SERVICE BULLETIN

N° 139-709

ATA 33 – PLACARD PROVISION REMOVAL

AW139 helicopters S/N 41801 thru S/N 41806.

Figure 1

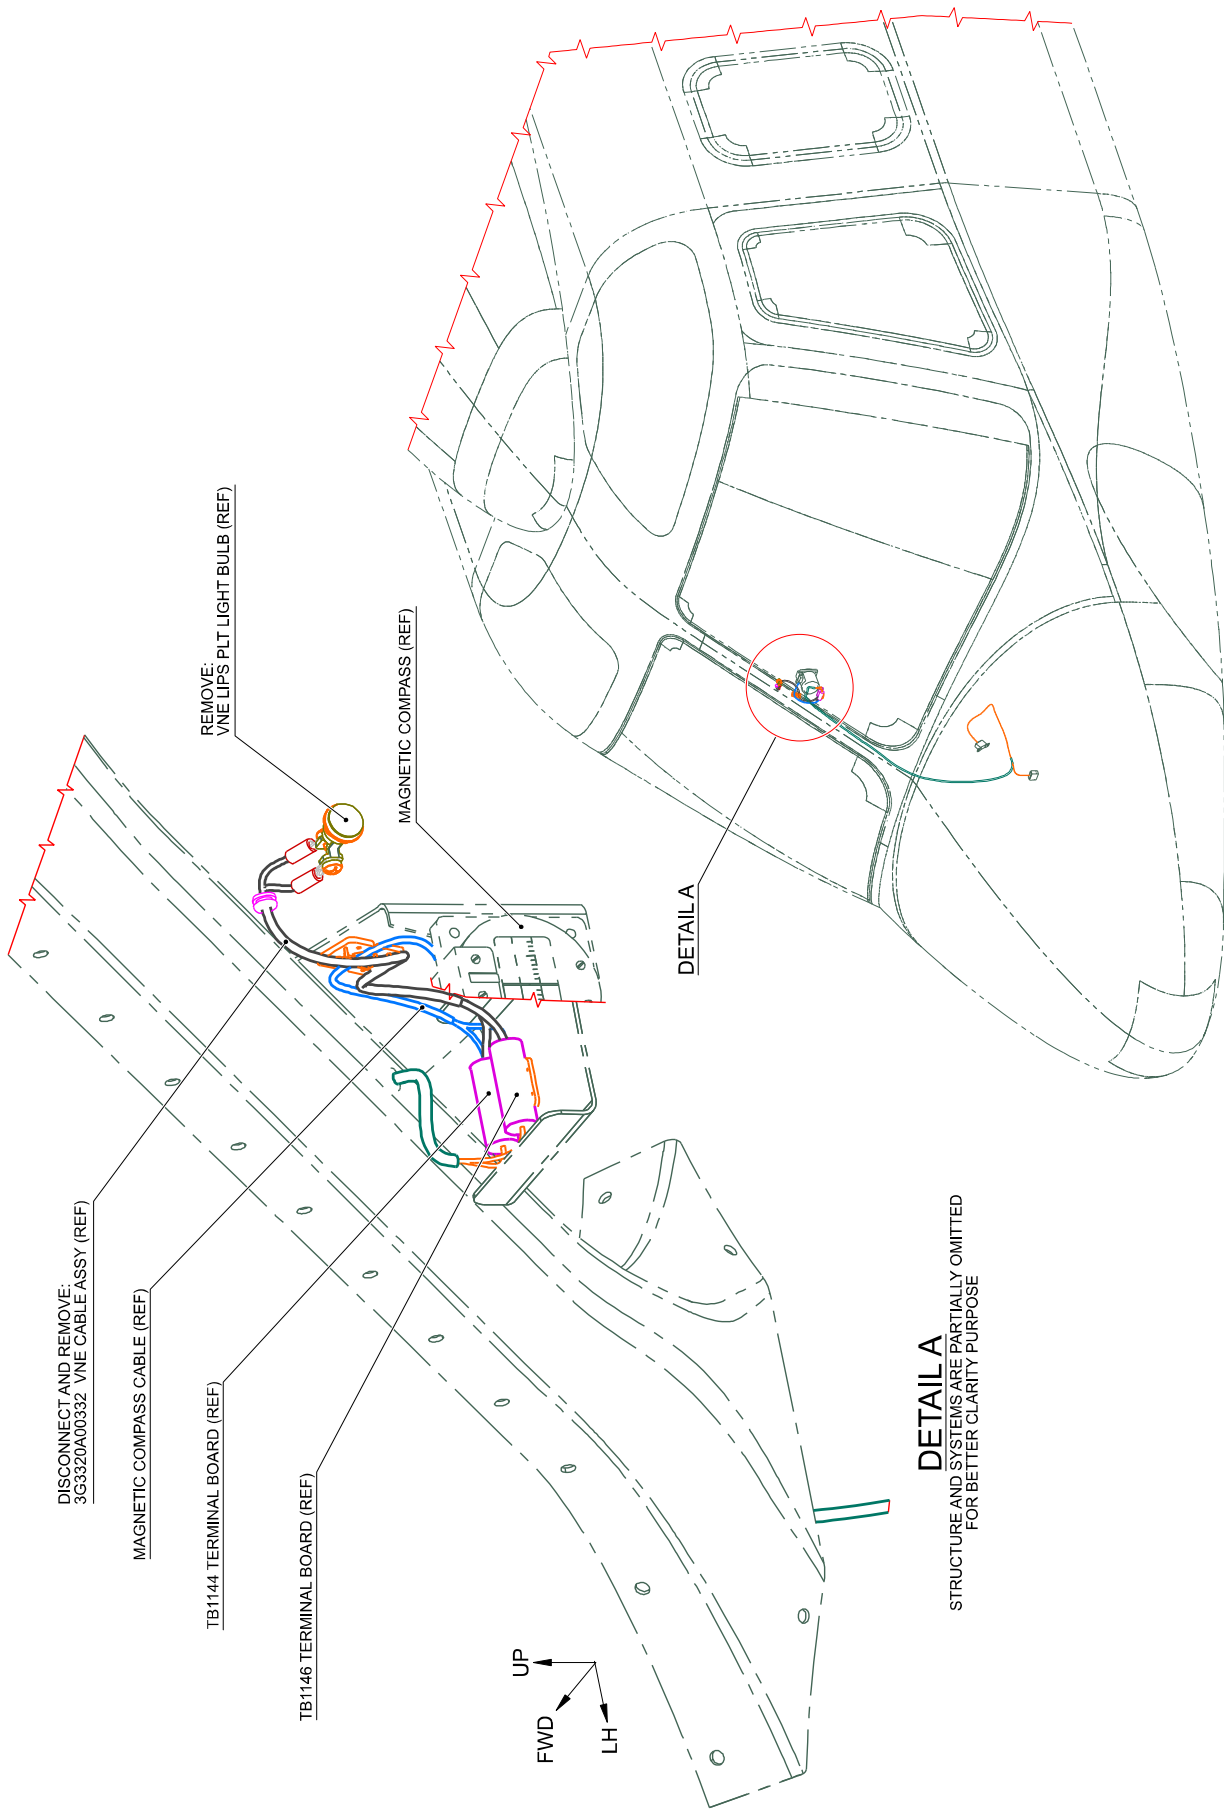
2. In accordance with AMP DM 39-A-06-41-00-00A-010A-A and with reference to Figures 1 and 2, remove all external panels, internal panels and internal liners as required to gain access to the work area .

- 3.1 With reference to Figure 1 and Figure 3 Wiring Diagram, remove the VNE cable assy P/N 3G3320A00332 as described in the following procedure:
 - 3.1.1 With reference to Figure 3 Wiring Diagram, disconnect the pin 2C of the GND wire from the terminal board TB1144.

Figure 2

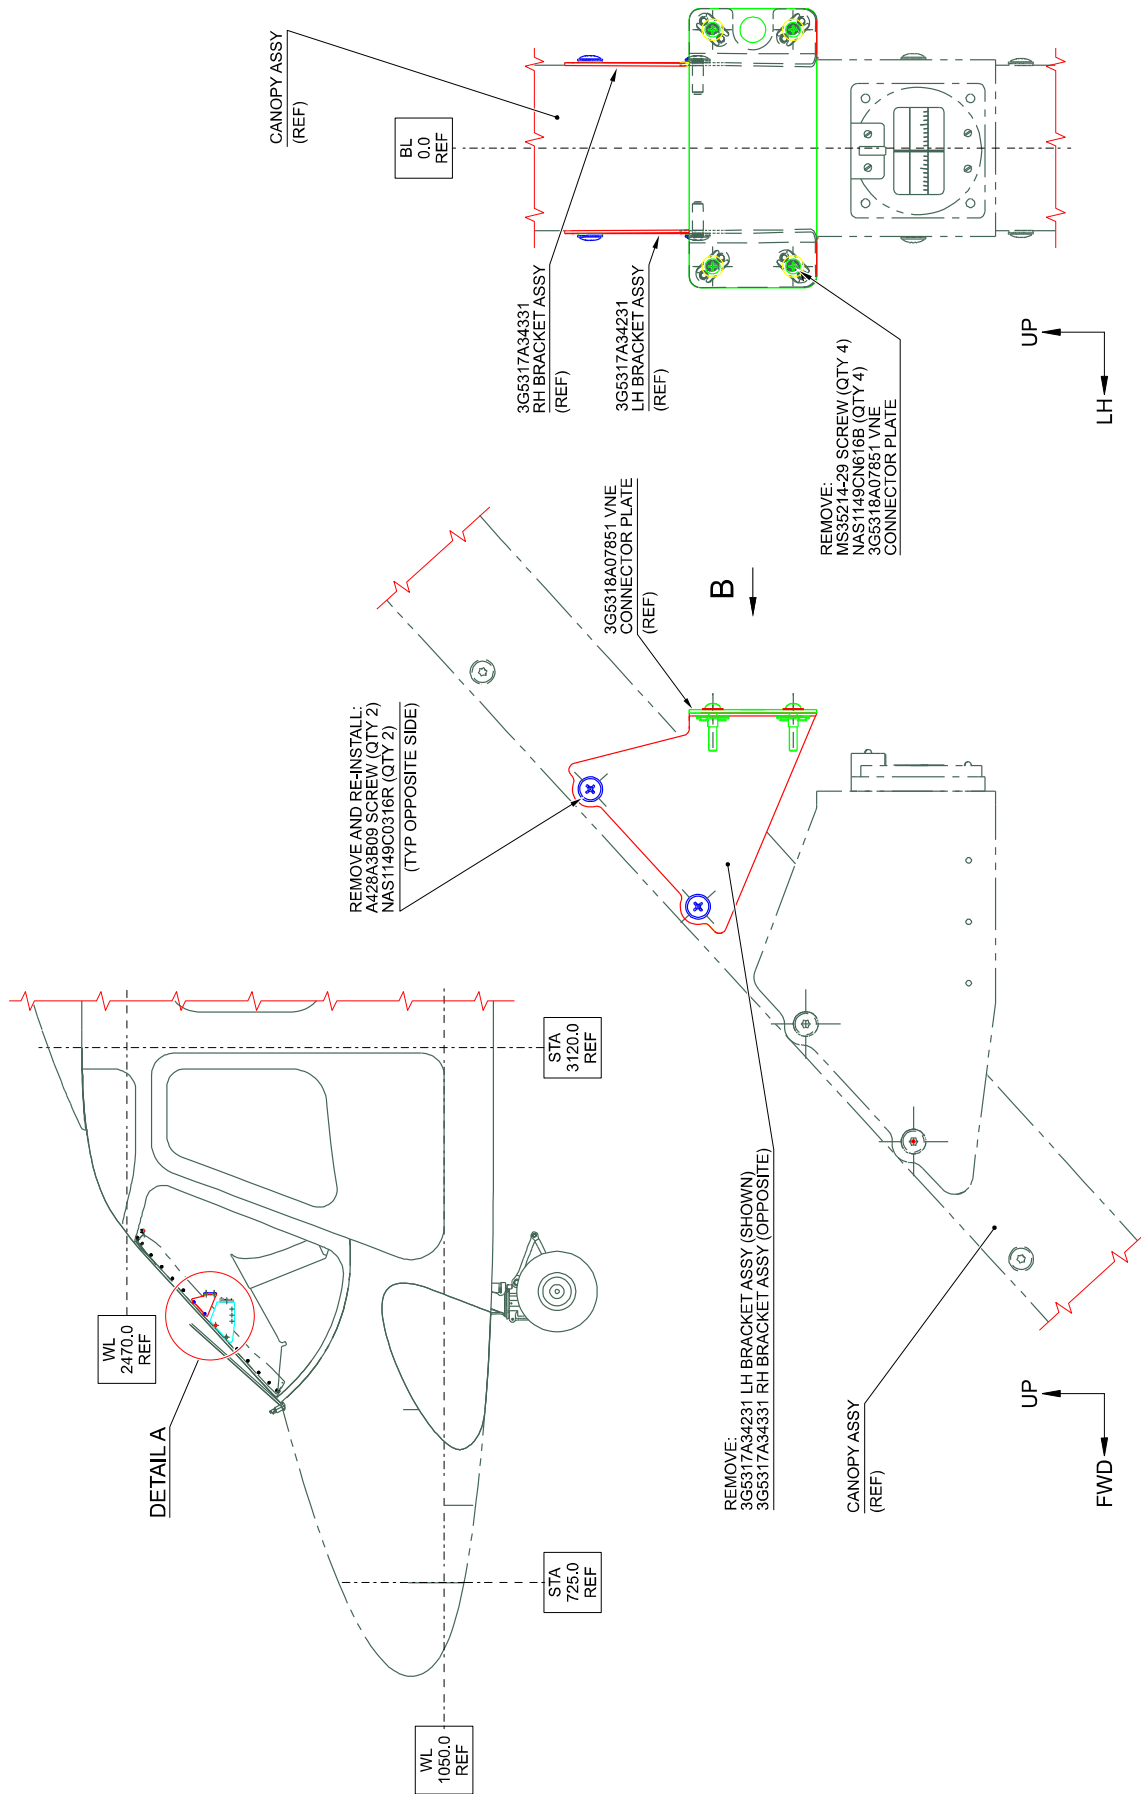
- 3.1.2 With reference to Figure 3 Wiring Diagram, disconnect the pin 2C of the PWR (28VDC) wire from the terminal board TB1146.
 - 3.2 With reference to Figure 2 View B, remove the n°4 screws P/N MS35214-29 and the n°4 washers P/N NAS1149CN616B that secure the VNE connector plate P/N 3G5318A07851 to the LH and RH bracket assy.

- 3.3 With reference to Figure 2 View B, remove from the helicopter the VNE connector plate P/N 3G5318A07851 and the attached wires disconnected from TB1146 and TB1144.

- 3.4 With reference to Figure 2 Detail A, remove the n°4 screws P/N A428A3B09 and the n°4 washers P/N NAS1149C0316R that secure the LH bracket assy P/N 3G5317A34231 and the RH bracket assy P/N 3G5317A34331 to the canopy assy.
- 3.5 With reference to Figure 2 Detail A, remove the LH bracket assy P/N 3G5317A34231 and the RH bracket assy P/N 3G5317A34331 from the helicopter.
- 3.6 With reference to Figure 2 Detail A, re-install the n°4 screws P/N A428A3B09 and the n°4 washers P/N NAS1149C0316R to plug the holes on the canopy assy.
4. In accordance with AMP DM 39-A-06-41-00-00A-010A-A re-install all external panels, internal panels and liners previously removed.
5. Return the helicopter to flight configuration and record for compliance with this Service Bulletin on the helicopter logbook.
6. Send the attached compliance form to the following mail box:
